FCC Class II Permissive Change Request Letter

RE: FCC Permissive II Change Request for Company: TCL OVERSEAS MARKETING LTDFCC
ID:2AZVS-B600A

PD41S_Difference content

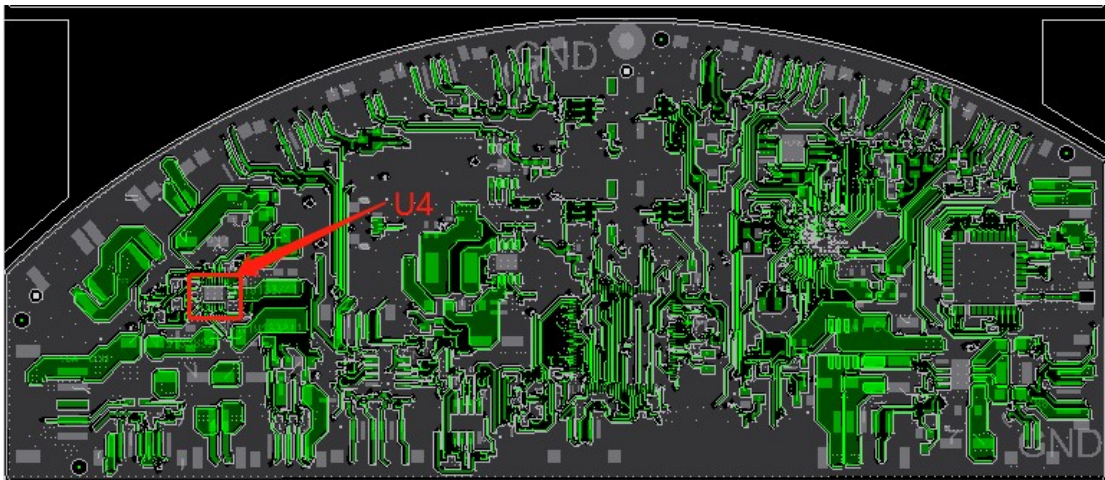
1、 Q28 and q34 are adjusted from rc3407 to dtm4417 (Q44 and Q45)

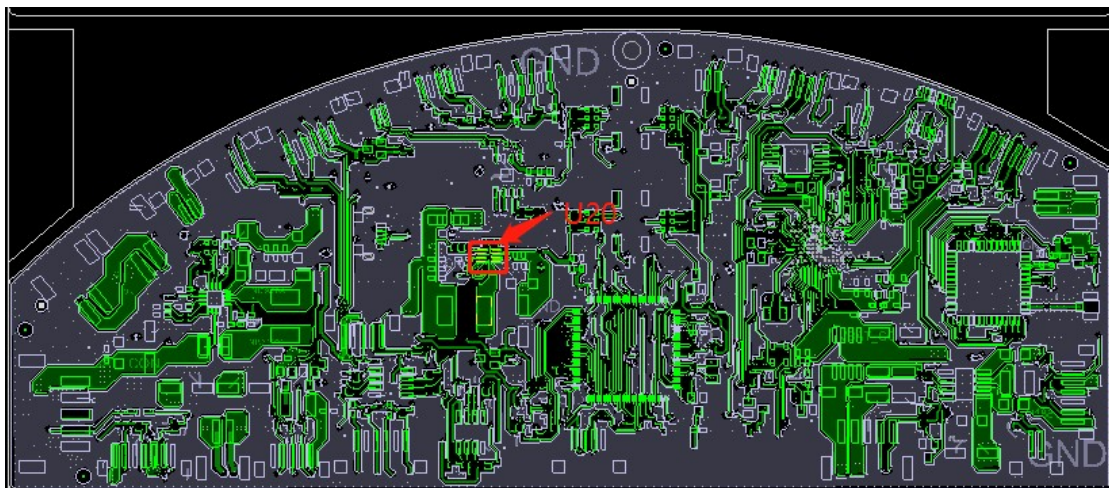
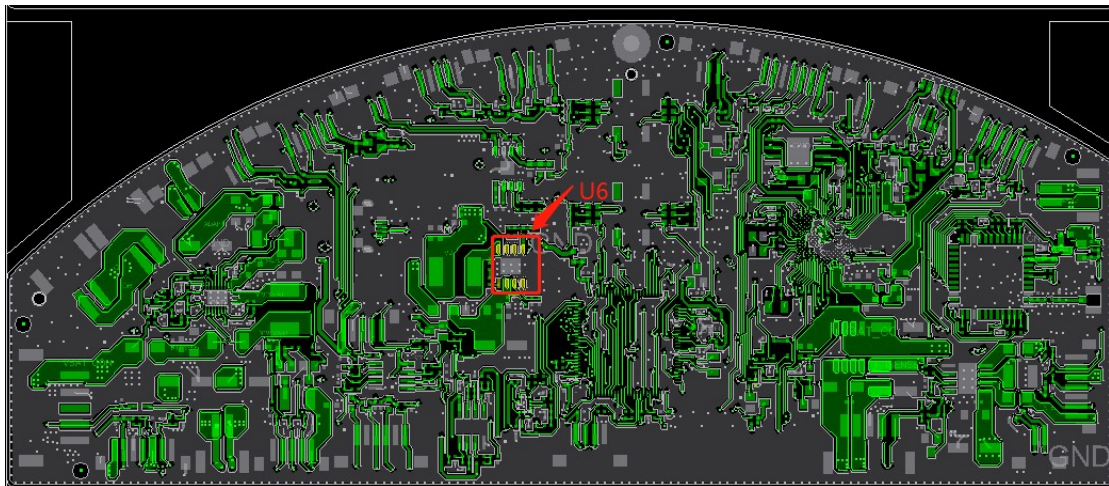
2、 The charging IC is adjusted from sc89171 (U4) to mp26124 (U19)
